Cambridge WWTP Relocation Project

Transport Review – Mike Axon

Anglian Water Services Ltd

Document Ref: 8.26

Figure 3.1 – Comparison of TEMPro 7.2 vs 8.1

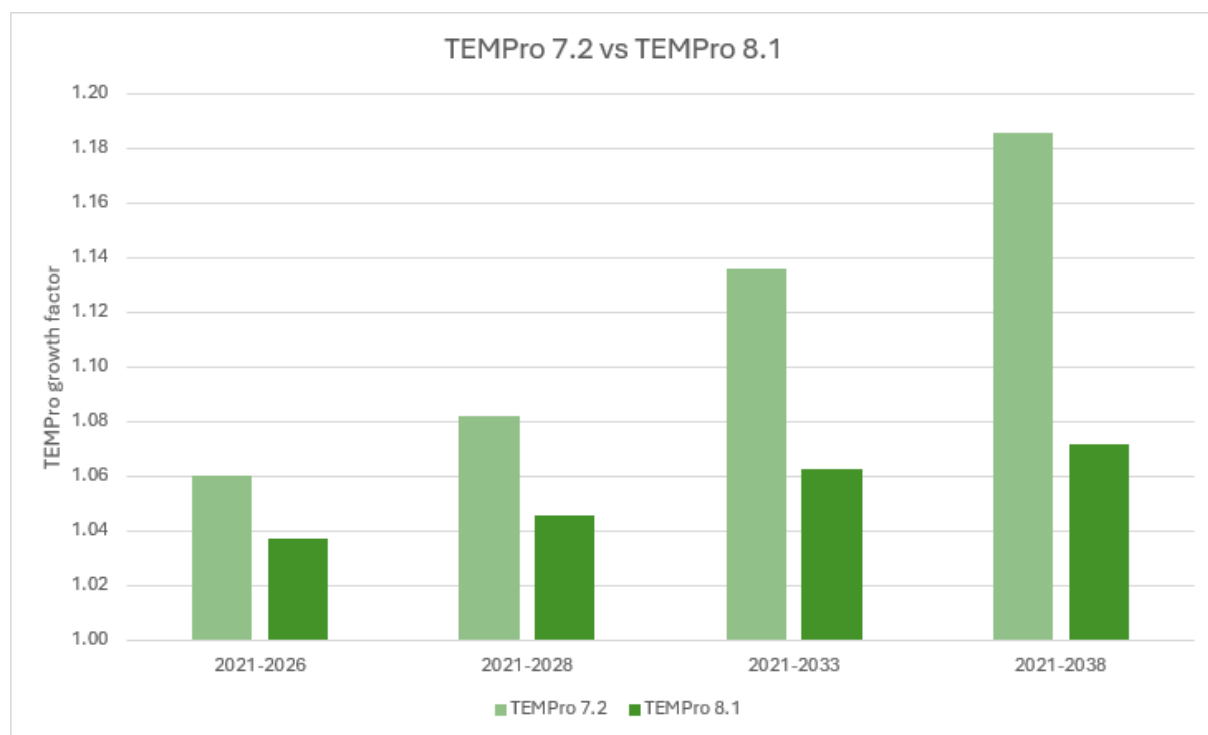
- 3.5 The TEMPro forecasts applied come from a now out of date version, TEMPro 7.2⁴. The latest version, TEMPro 8.1, was issued in September 2023, and contains substantially lower forecasts for traffic growth. However, it is acknowledged that MM used the available version of TEMPro at the time. **Figure 3.1** shows the difference between the two versions.

- 3.6 For instance, the traffic growth forecast from 2021 to 2038 in the current version is just 39% of that in the superseded version.
- 3.7 The consequence of this is an overestimate of background traffic on the network, although not to the extent that this is likely to make a difference to any of the assessments either way. In traffic impact terms it provides extra cause for comfort in that the assessment in the TA is more robust than it needs to be in this respect. There is certainly no reason to change the judgements made as a result of the assessments on the basis of this difference in forecasts.

Figure 4.3 – A14 J34 Off-slip – Total Vehicles and HGVs

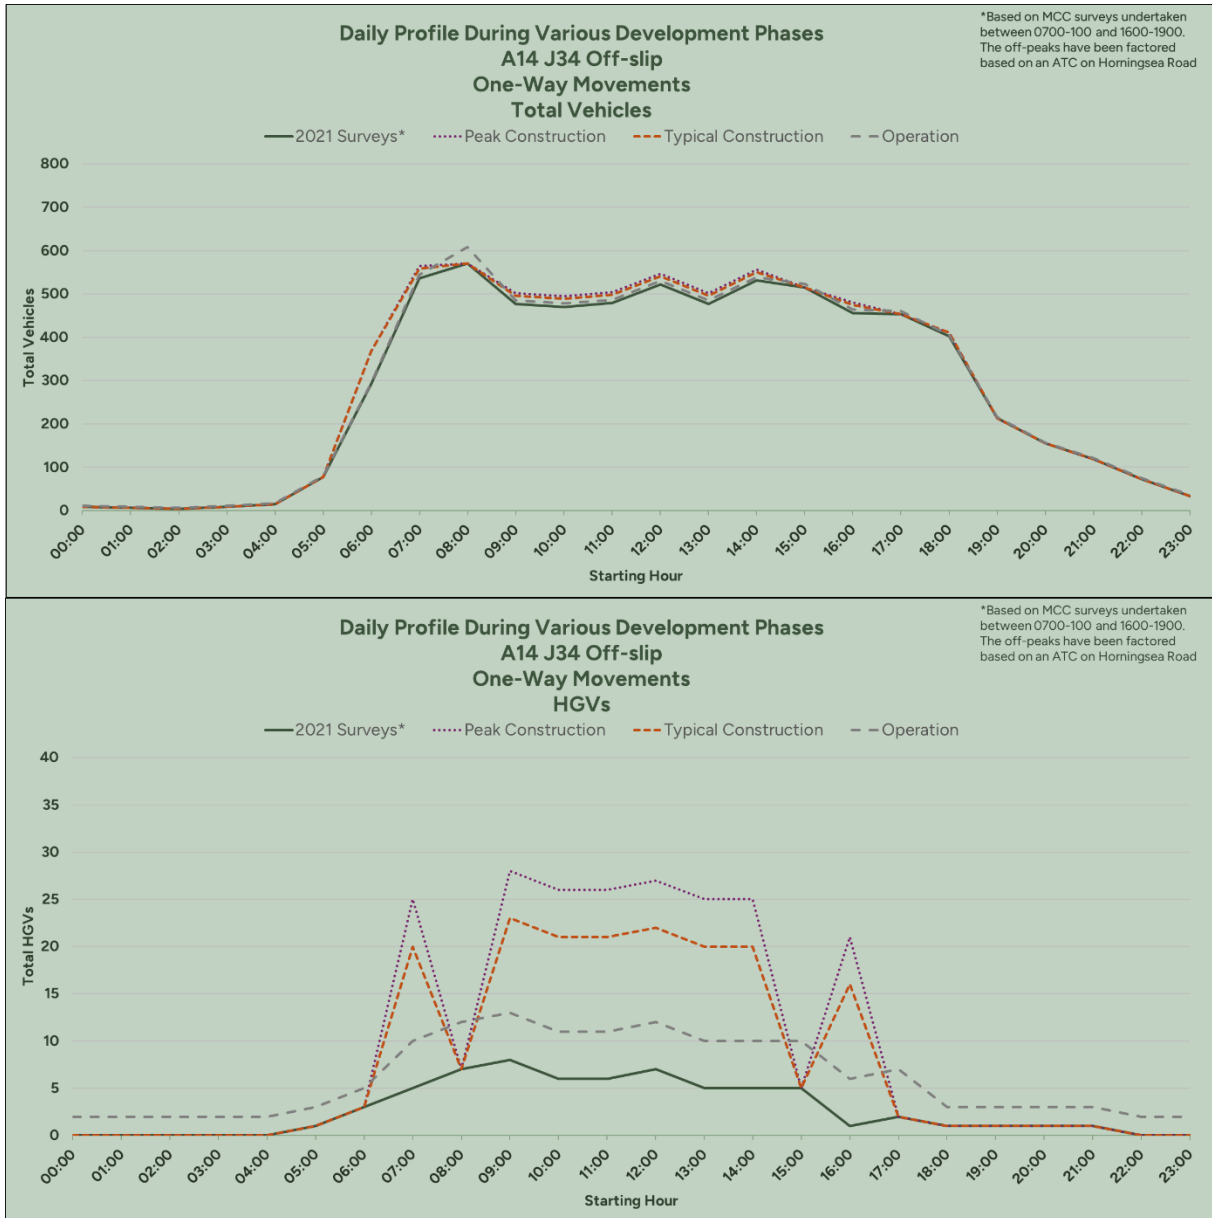
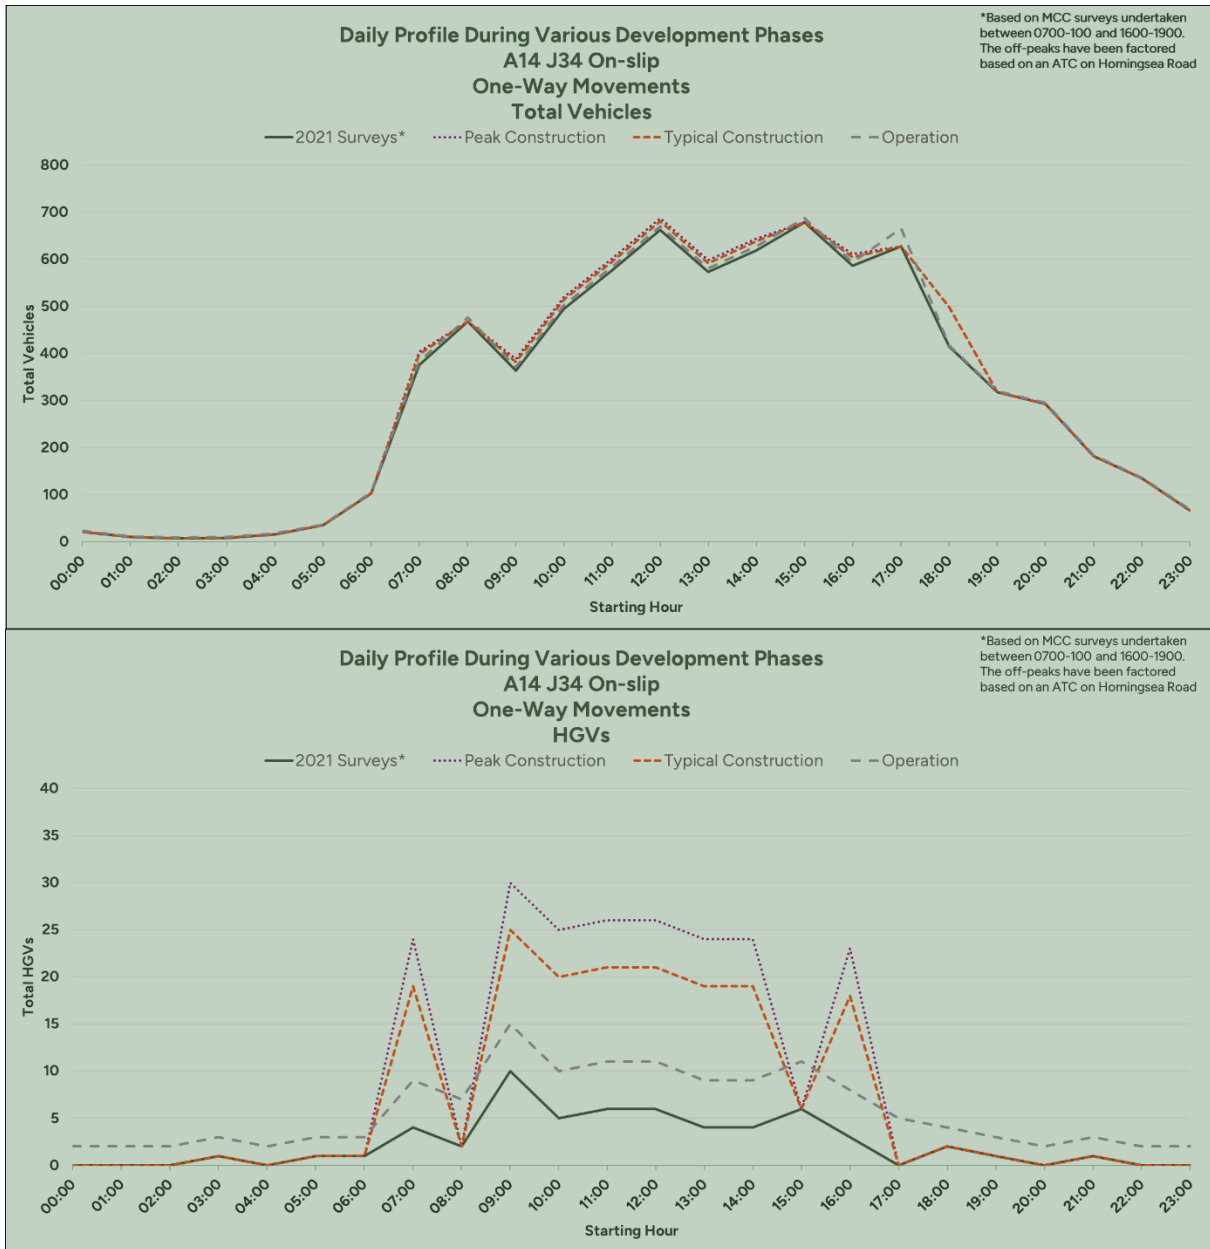
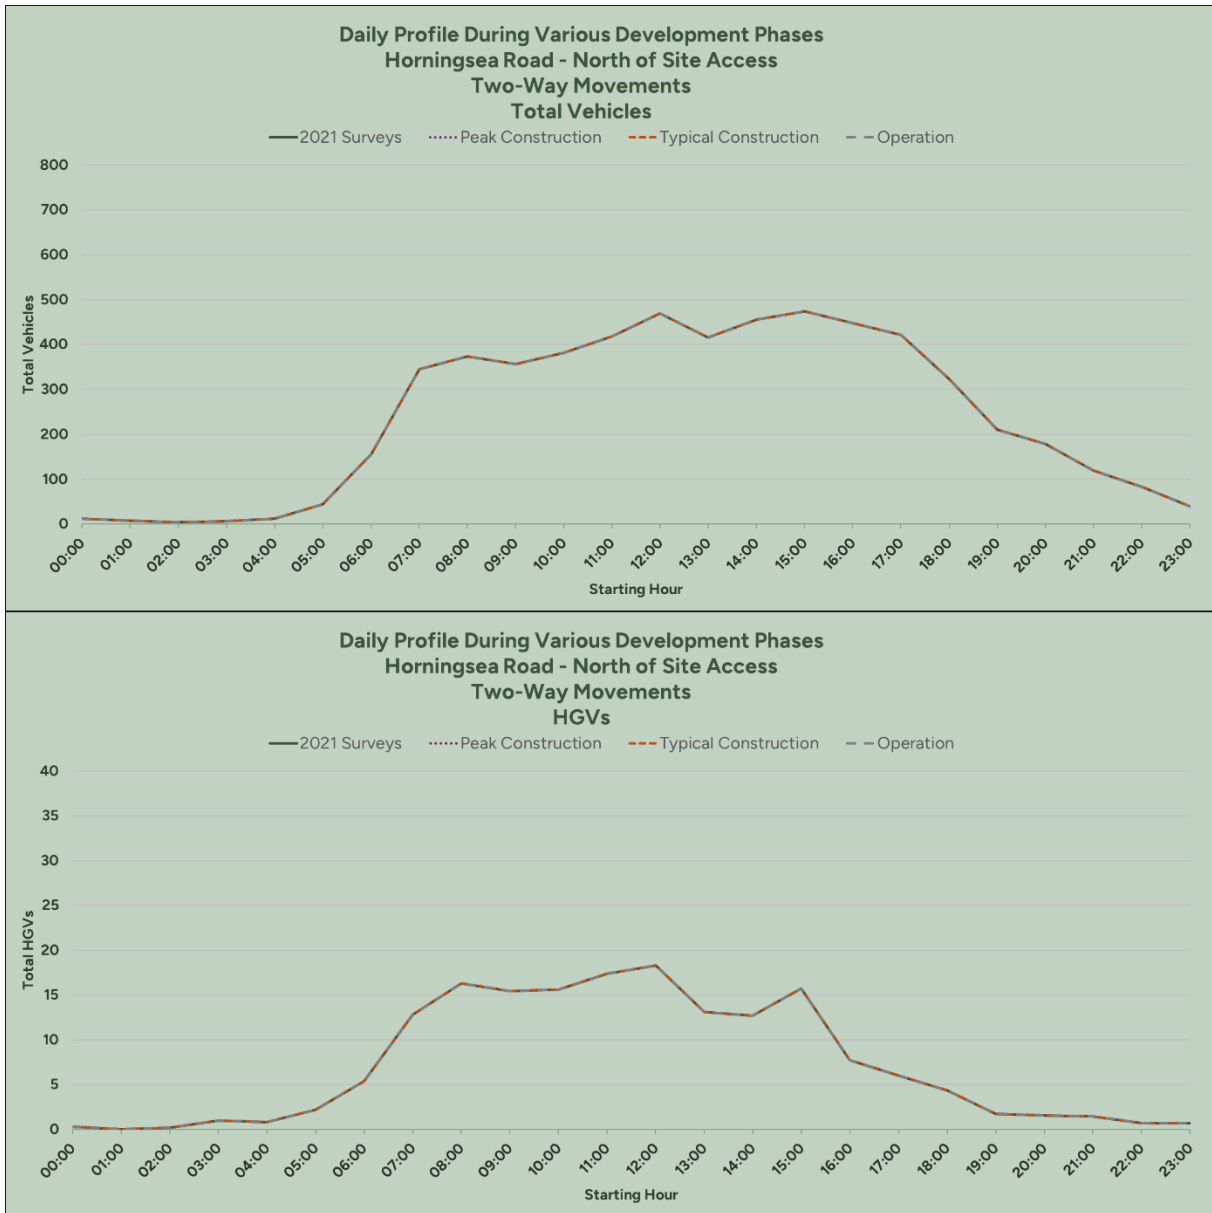
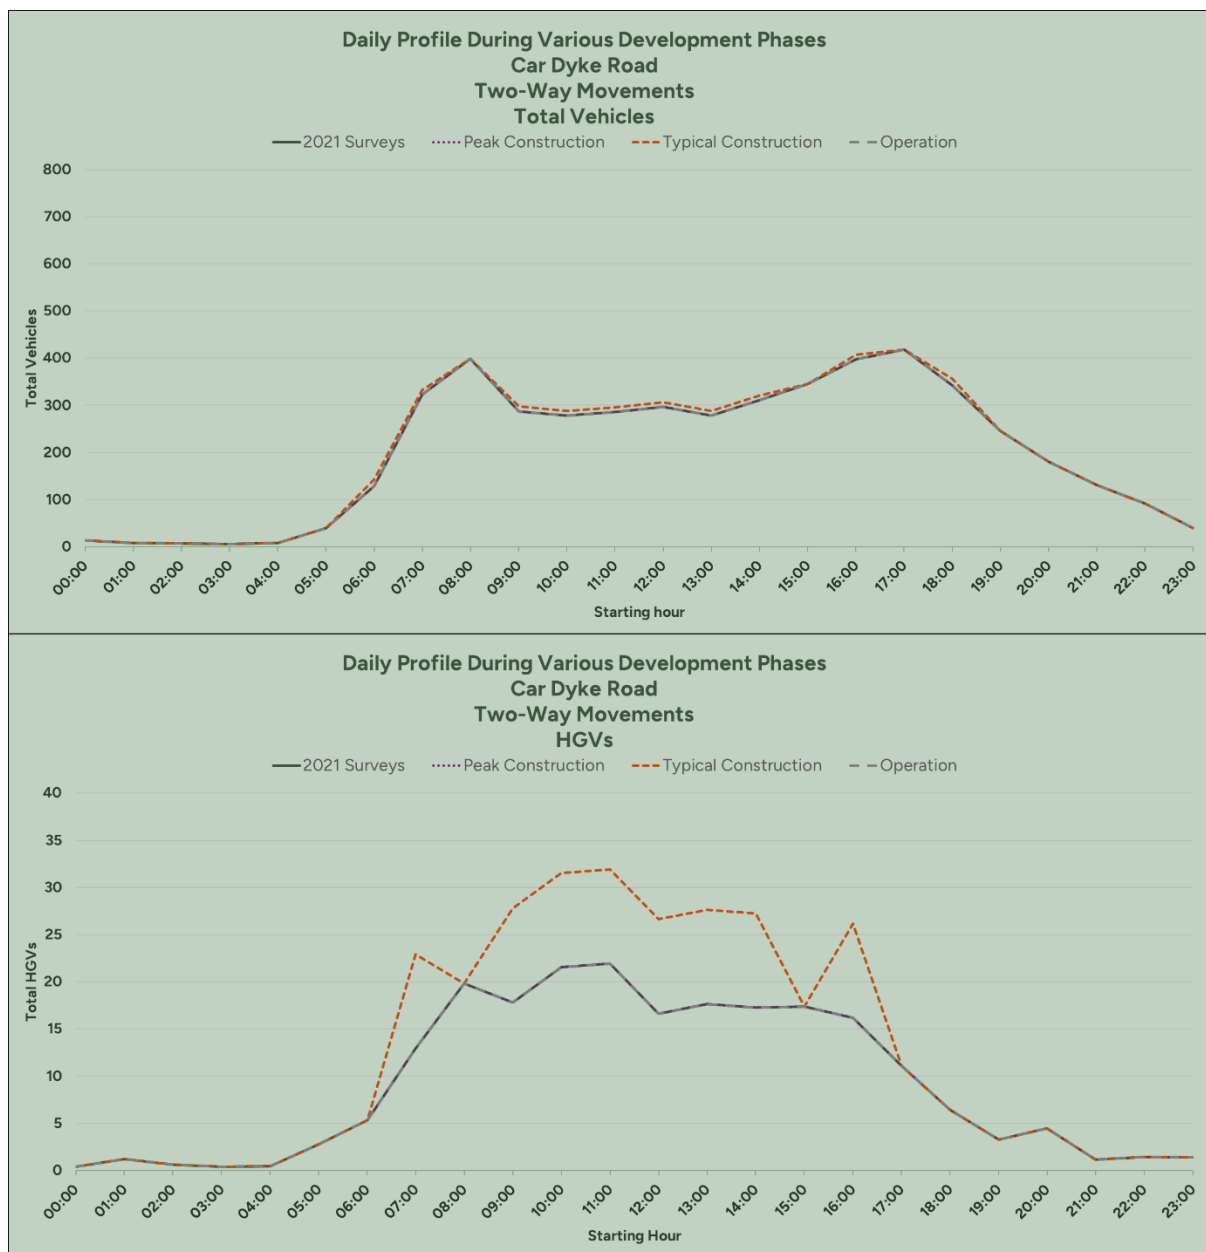
- 4.10 **Figures 4.3 – 4.6** show the hourly profiles at these locations compared with background traffic flows. The development flows and the background traffic flows are taken from the TA¹³. The development flows are based on the TA’s statement that construction traffic,

- 4.11 At Figures 4.5 (Horningsea Road north of the site access) the lines have merged as the design and routing management results in no development traffic passing that point.
- 4.12 The IEMA guidelines referred to in the TA (1993) provide a guide relating change in traffic flow to environmental effect.
- 4.13 The guidelines referred to in the TA have been superseded by a revised version issued in July 2023. The same general rule of thumb applies¹⁴. Different environmental effects are sensitive to different changes in traffic flow. However, the general rule of thumb is that a

- 4.14 On the basis of the hour by hour assessment in **Figures 4.3 – 4.6**, all instances of total development traffic fall well below a 30% uplift in traffic and where the HGV uplift is substantial in percentage terms, it is against a very low baseline, and the absolute volume of HGVs remains low (for instance the 667% uplift in HGVs on the A14 J34 On Slip at 1600 – 1700 is caused by 20 HGVs in addition to the baseline 3 HGVs). The small absolute number, in association with no significant receptors in this location, and no significant effect on any receptors in this location leads to a reasonable judgement of no discernible effect.

Figure 5.1 – Horningsea Road / A14 (J34) / Site Access – 2026 Future Base vs 2026 Peak Construction

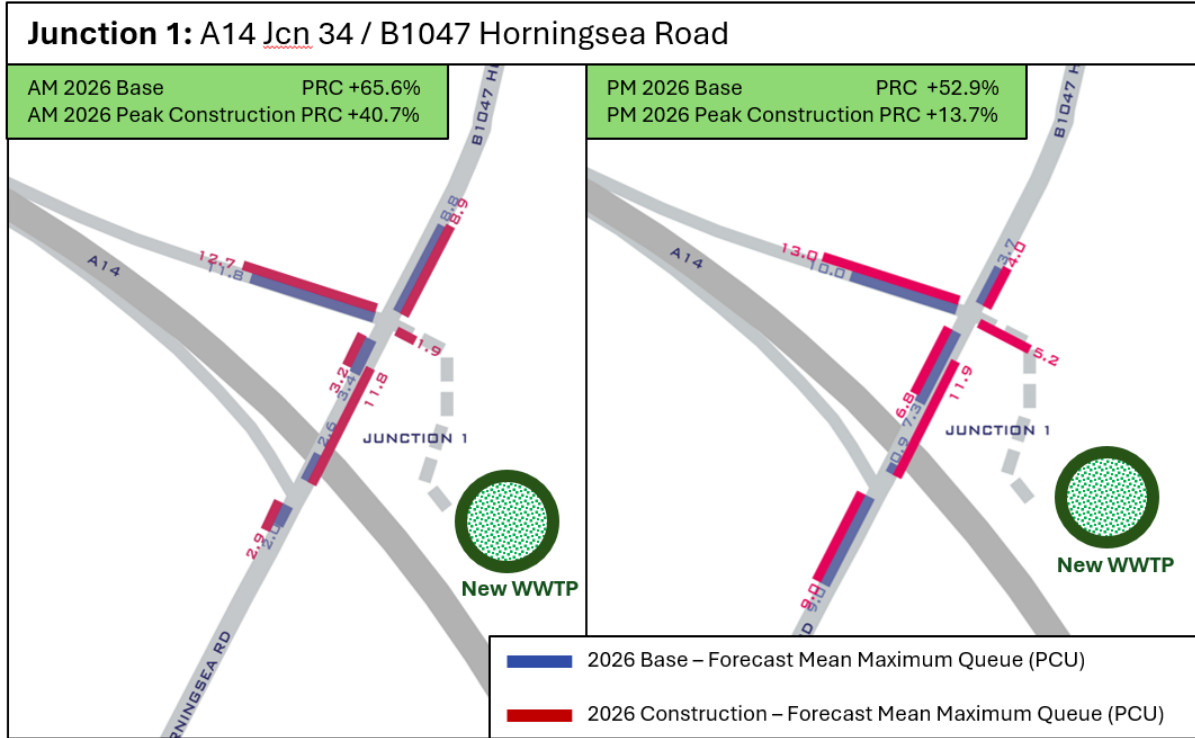
5.18 **Figure 5.1** summarises the junction performance during ‘peak construction’ based on the TA analysis²⁰.
